ASHLAND DAM LAKE - INITIAL ASH DISPOSAL AREA INSPECTION

On September 1, 1971, Mike Brown of DEP in Chattanooga; L. E. Hambley, Assistant Plant Superintendent; W. G. Elyot, Assistant Mechanical Supervisor; and I inspected the ash disposal areas at Kingston Steam Plant and discussed our findings with A. C. Spencer, Plant Superintendent.

GENERAL	
ASH DISPOSAL AREA	
KINGSTON STEAM PLANT TENNESSEE VALLEY AUTHORITY	
SUBMITTED	RECOMMENDED APPROVED
<i>R. M. ...</i>	<i>R. M. ...</i>
NOXVILLE	6-8-51 38 C A ION400 24

SECTION THROUGH NORTH DIKE AND STORAGE AREA
N.T.S.

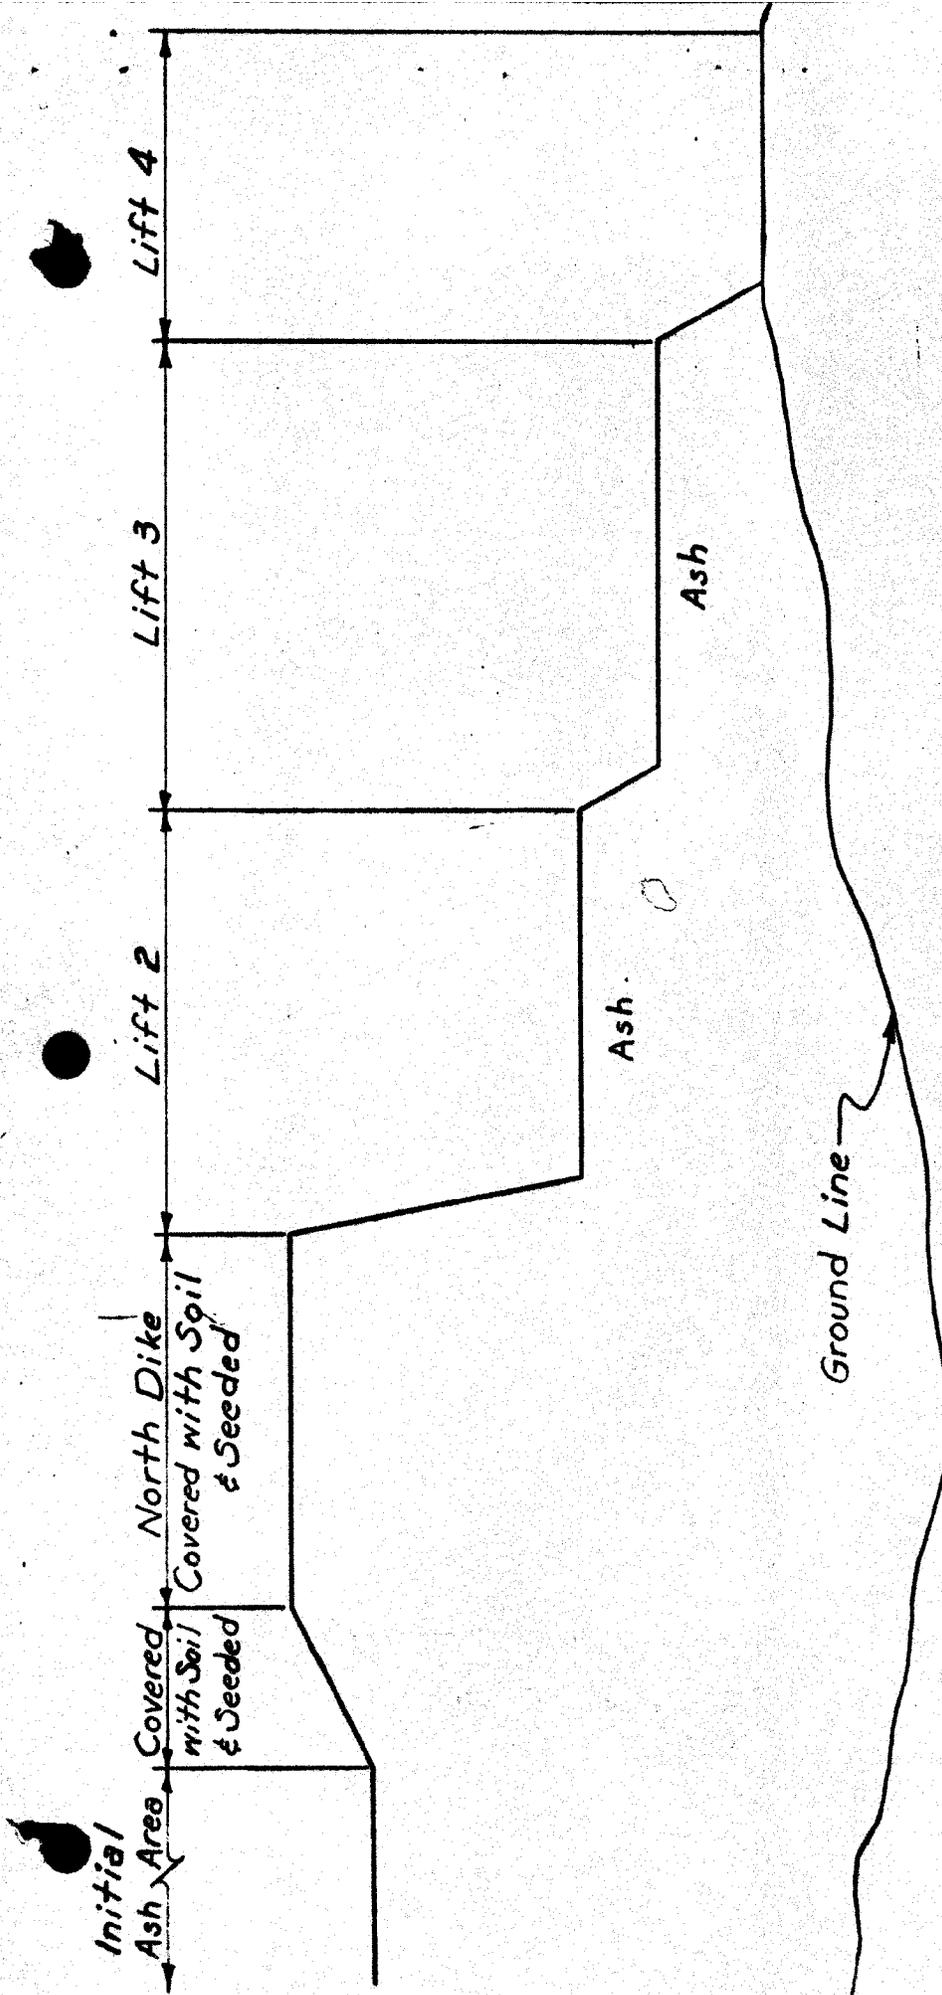
The ash is excavated by draglines near the outfall, piled on top of the dike, allowed to dry, then hauled with earthmoving equipment and deposited as shown on the attached sketch.

The north side of the initial area has been widened and raised to additional eight to ten feet. The south slope and top of the north dike have been covered with four to six inches of soil, loam, fertilized, and seeded (photos 1 and 2).

Note: Lifts 2, 3 and 4 will be covered with soil, fertilized, limed and seeded when they reach the elevation of the North Dike.

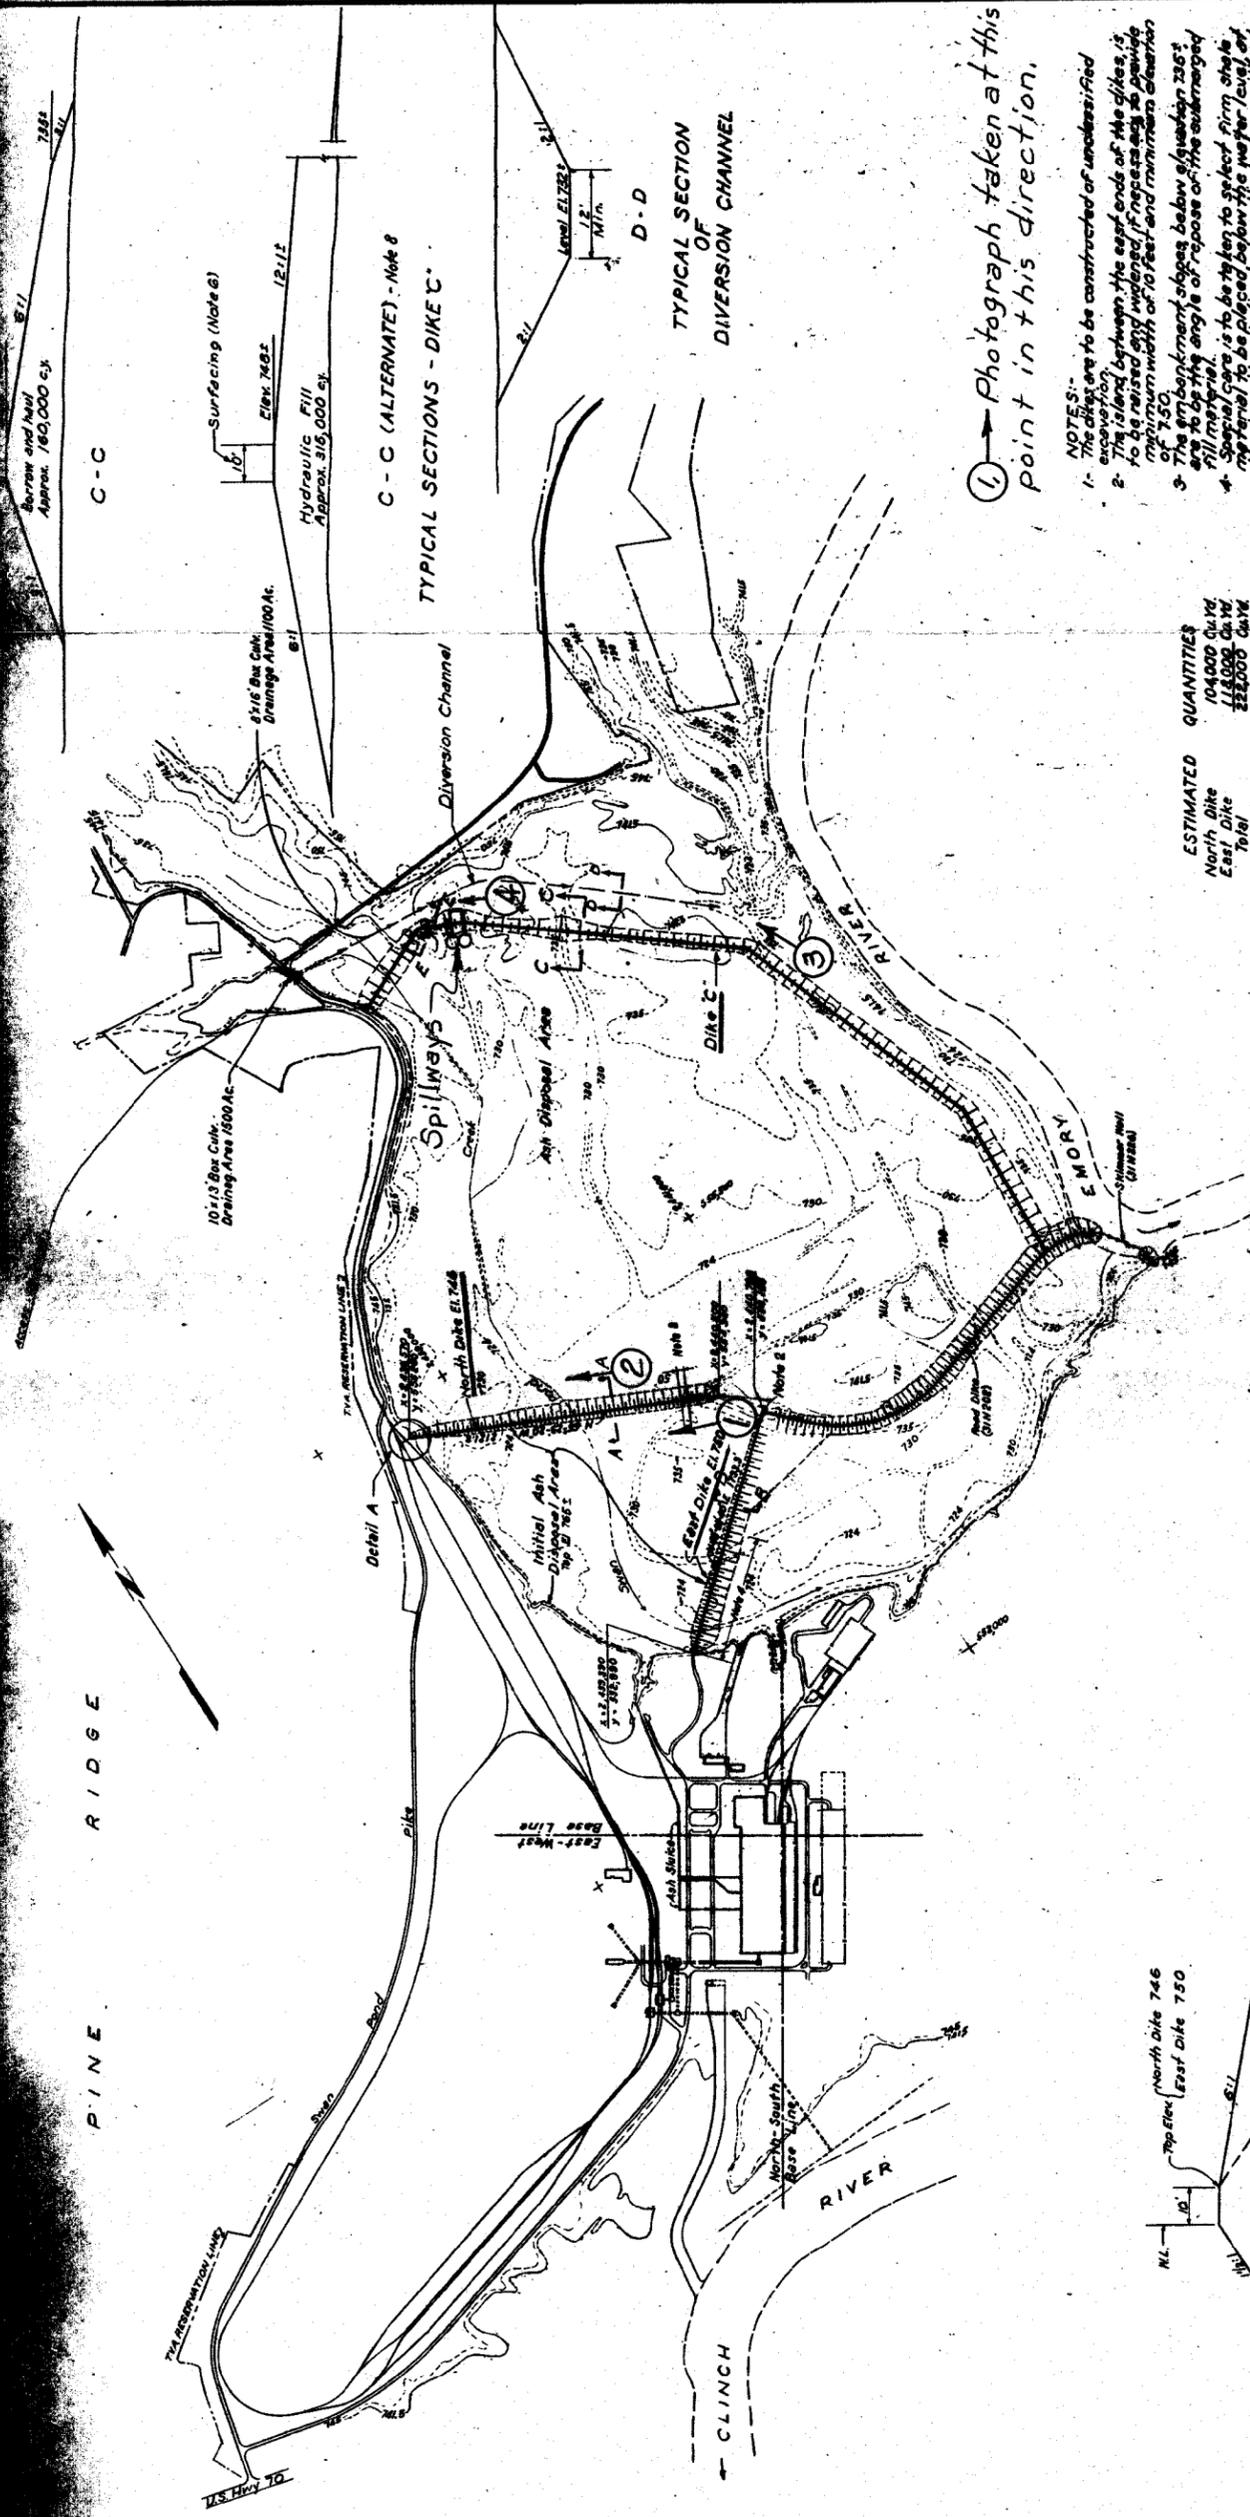
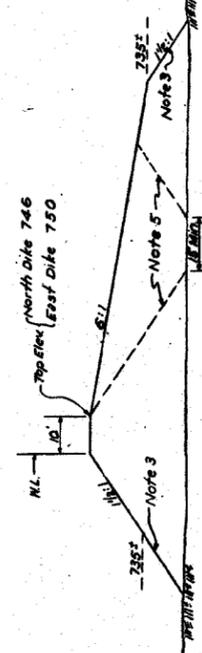
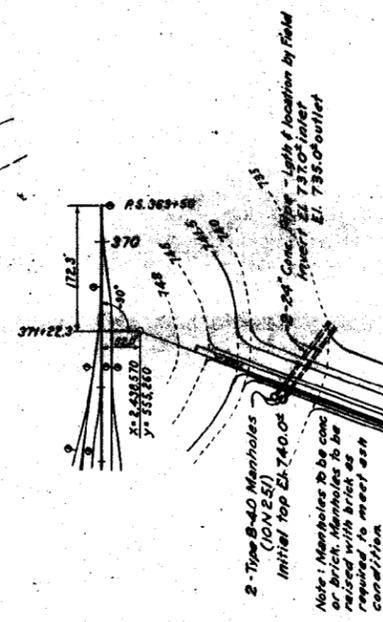
The attached print of drawing 105400 shows the areas described and location of pictures taken.

In general, the dikes are in good condition with no evident stability problems. The original dikes were constructed with earth. The dikes around the initial ash area were raised with ash.

All dikes have been raised to provide a minimum 4-foot freeboard between the water surface and the top of the dikes with the top kept smooth and sloped to the inside.

Widening of dike C to provide a base for future raising has progressed to near the spillways and should be completed.

1. Continue to operate the rock screen as it was being done, but care should be used to insure that the rock that has not settled out in the initial area does not fill the main area before the rock dike and dike C are raised.
2. Complete the widening of dike C to form the base for future raising.
